NINEWA VILLAGE ROADS  
SEGMENT 3  
GOVERNORATE OF  
NINEWA, IRAQ

**SIGIR PA-06-035**  
**APRIL 5, 2006**

SUBJECT: Report on Project Assessment of Segment 3 of the Ninewa Village Roads in  
the Governorate of Ninewa, Iraq (Report Number SIGIR-PA-06-035)

**Diagram 1. Typical fill cross section**

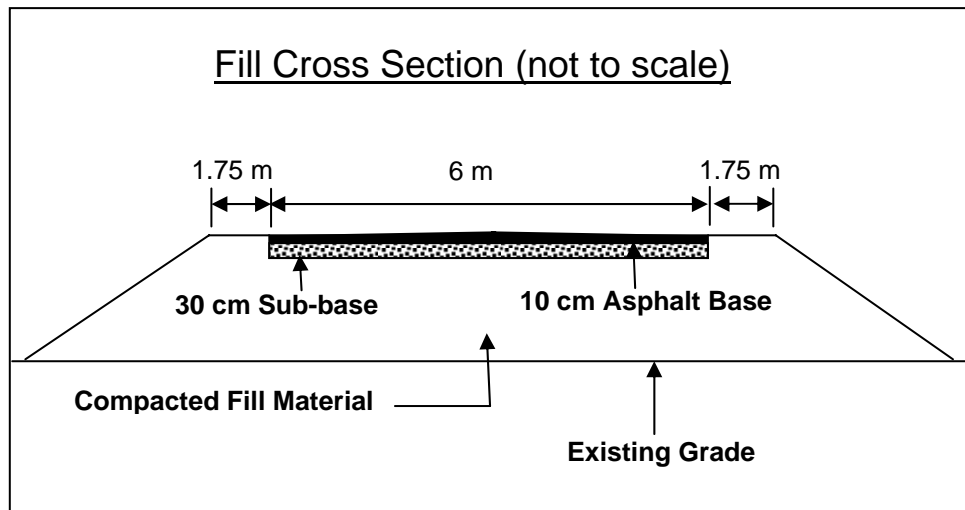
The contract BOQ included requirements for earthwork cut and fill sections. For fill sections, the contractor was required to clear and grub the natural ground to a depth of 10 cm and provide new suitable fill material compacted in layers of 20 cm to reach the profile contained in typical design cross section. For an illustration of a typical fill cross section, see Diagram 1.

**Diagram 2. Typical cut cross section**

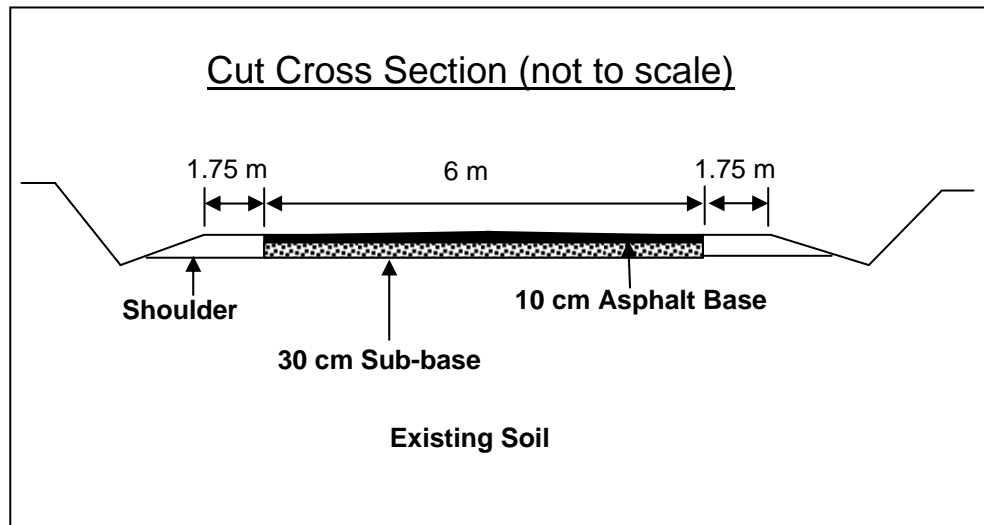
On a cut section, unneeded materials are removed so as to match the elevations provided in the design profile. Diagram 2 provides an illustration of a typical cut section.
